Mitigation Plan
Pen Dell Mitigation Project
Johnston County, North Carolina
FINAL VERSION

NCDEQ DMS Project Identification # 97079
NCDEQ DMS Contract # 6824
Neuse River Basin (Cataloging Unit 03020201)
USACE Action ID Number: SAW-2016-00885
Contracted Under RFP # 16-006477

North Carolina Department of Environmental Quality
Division of Mitigation Services
1652 Mail Service Center
Raleigh, NC 27699-1652
November 2017

FIGURE 9

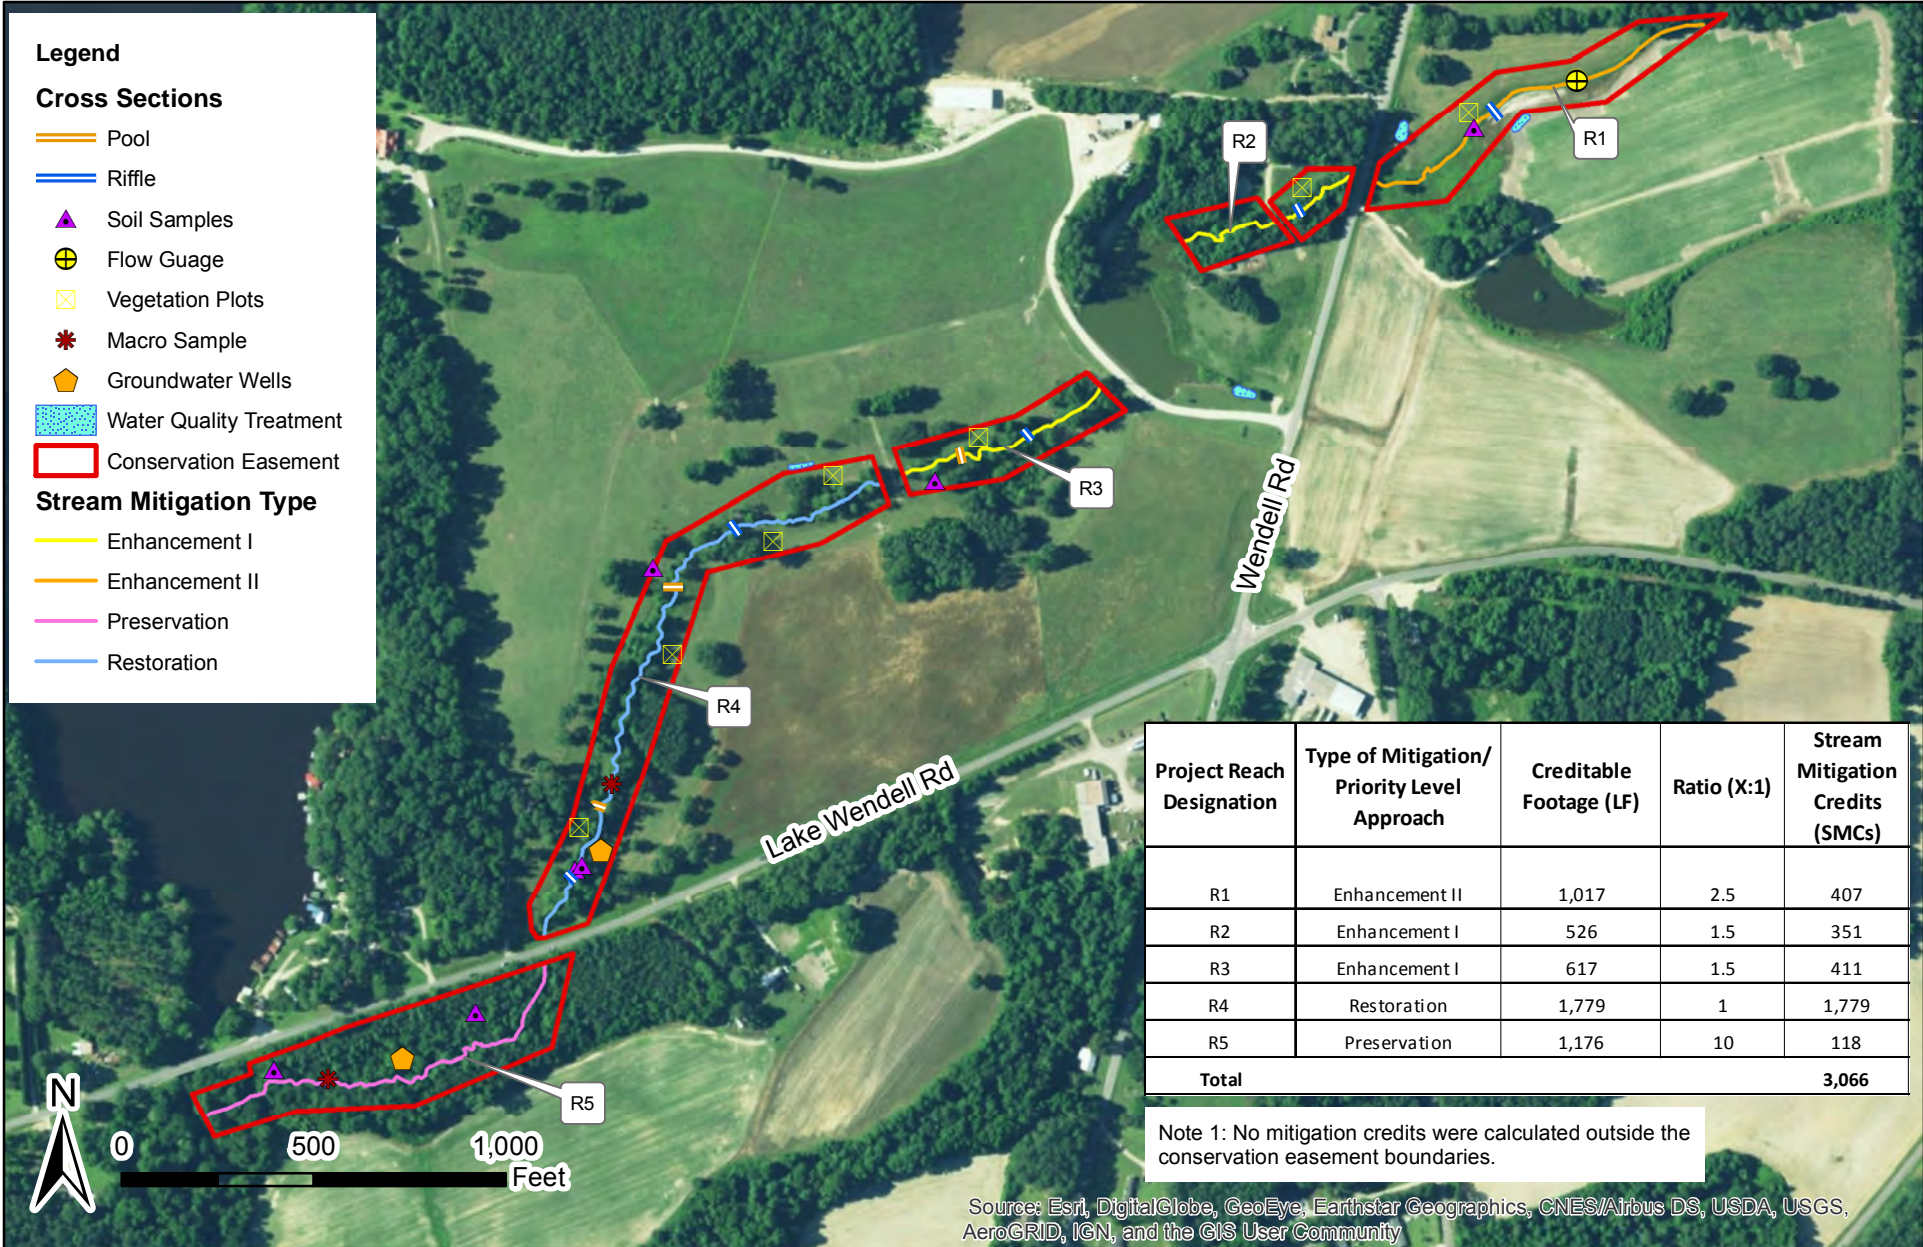
6. DWR recommends placing the in-stream gauge on R1 midway down the reach and not toward the bottom of the reach. Response: WLS will install the in-stream flow gauge midway down the reach and update Figure 10 accordingly.

3. According to the field notes, performance standards for Reach 1 must document the presence of stream features throughout the monitoring period. Also, the stream gauge should be located in the middle to upper section of the reach. Response: WLS will document the presence of stream features throughout the monitoring period and the stream gauge will be installed in the middle section of the reach as shown on revised Figure 10.

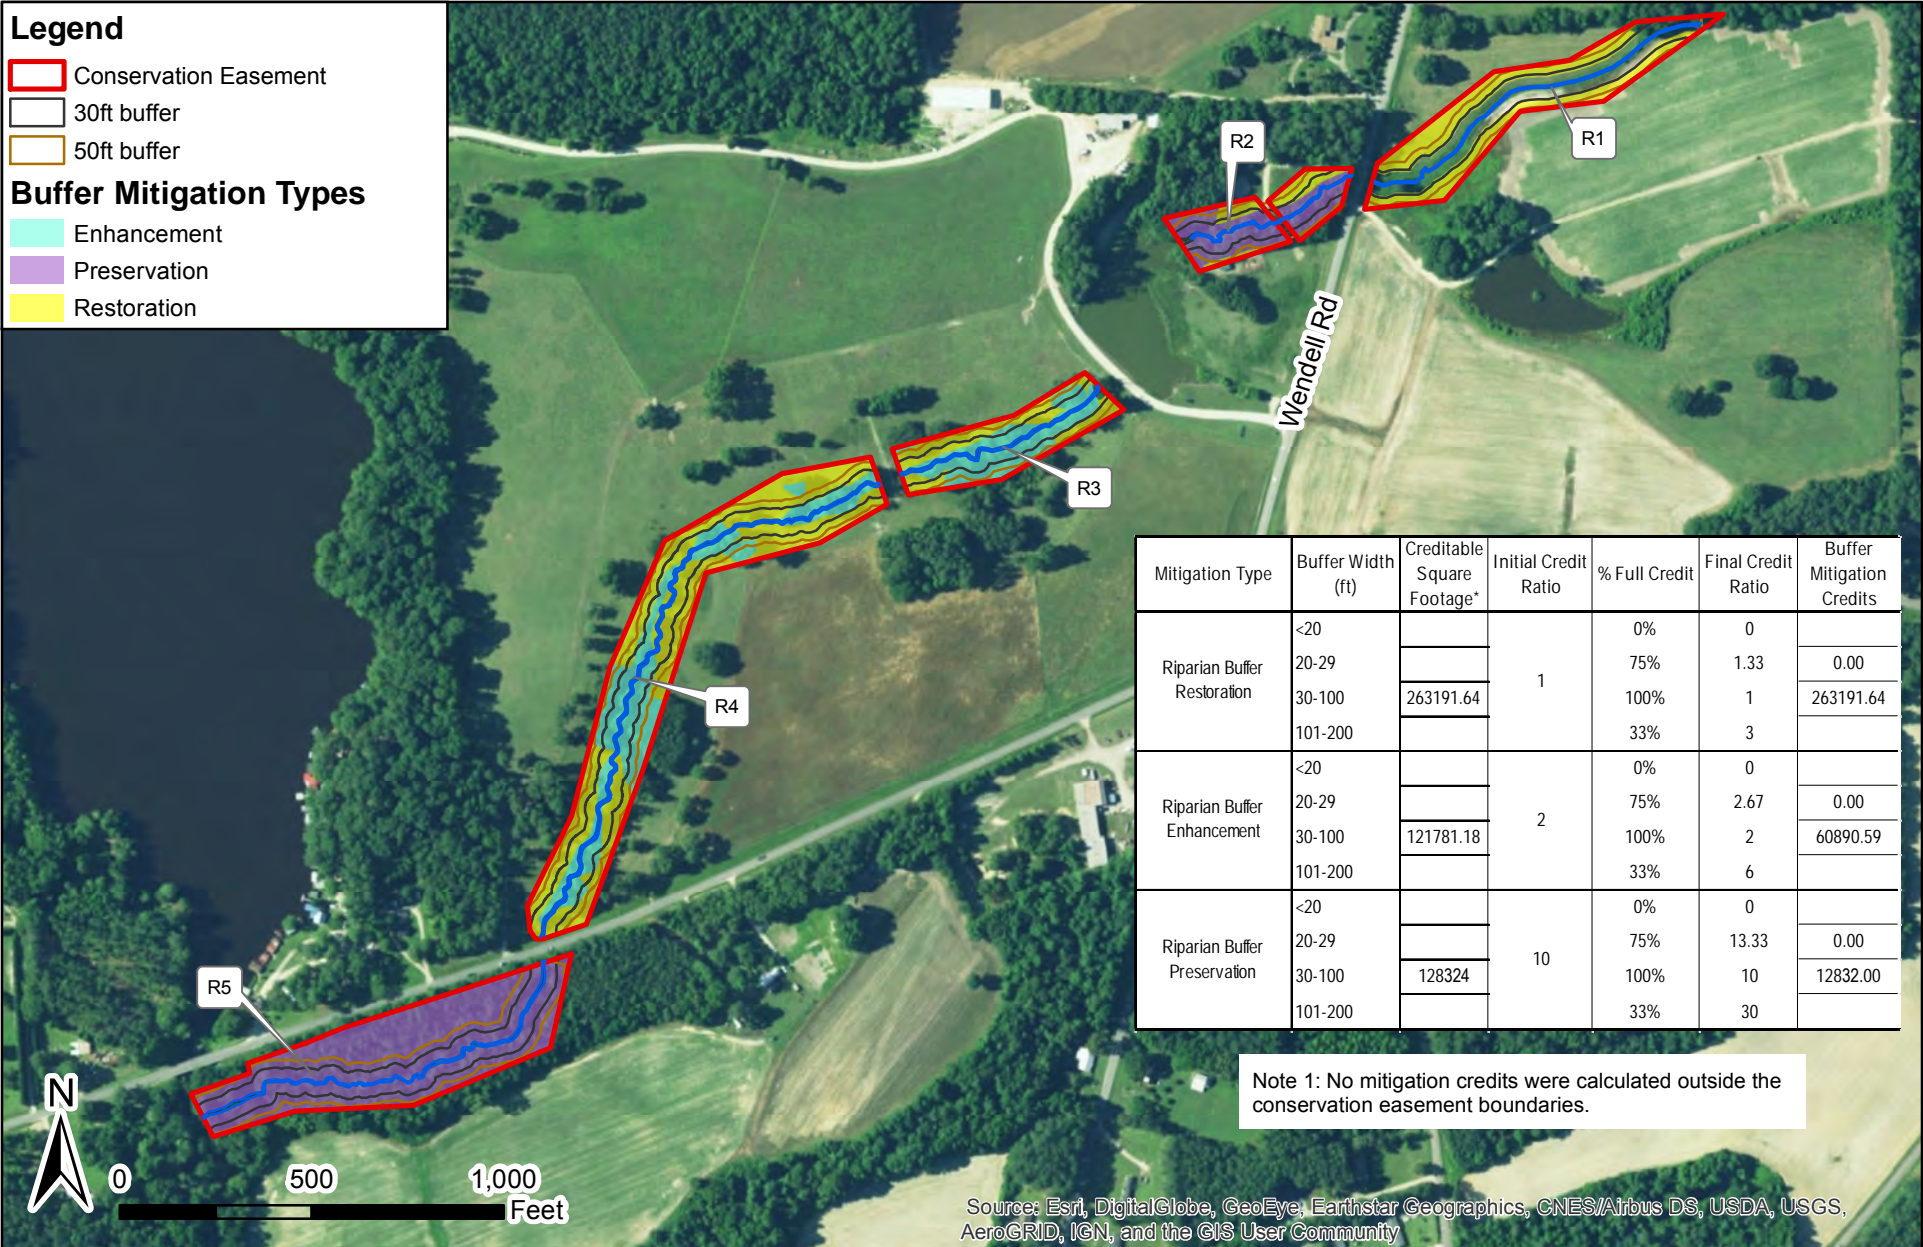
- Section 1.0:
 - Table 1 and Plan Sheet match for credit assets. However, Figure 11 shows 28ft² less for Preservation credits. This is okay, since the As-Built survey & corresponding report will provide that consistency between tables and Figures.

- Section 6.5
 - Text implies that areas generating buffer mitigation credit are not going to be within areas <50'. Please see comment below on Figure 11.

- See vernal pool comment at the bottom of comments
- Figure 11
 - Clarify widths to justify the 1:1 & 2:1 ratios by having them drawn out by computer. 1:1 applies for all widths that are a minimum of 30-100'. Anything greater than 100' gets only 33%. The plan sheets do not provide draft widths. Even though text throughout states nothing will be less than 50' from top of stream banks, without seeing it visually representing on the Figures or Plans makes it difficult to verify they meet the rule. Here is one example showing where the widths were verified by computer, knowing that As-Built surveys may show slightly different measurements when streams are restored.

- **DWR Comment: Table 1 and Plan Sheet match for credit assets. However, Figure 11 shows 28 ft² less for Preservation credits. This is okay, since the As-Built survey & corresponding report will provide that consistency between tables and Figures.** WLS Response: Table 1, Figure 11, the Revegetation Plan (plan Sheets 15 through 18) have been compared and edited as needed for clarification and to provide more transparency in the Final Mitigation Plan with regards to the proposed riparian buffer mitigation limits, ratios, and credits.

- **DWR Comment: Text implies that areas generating buffer mitigation credit are not going to be within areas <50'. Please see comment below on Figure 11.** WLS Response: Table 1, Figure 11, the Revegetation Plan (plan Sheets 15 through 18) have been compared and edited as needed for clarification and to provide more transparency in the Final Mitigation Plan with regards to the proposed riparian buffer mitigation limits, ratios, and credits.
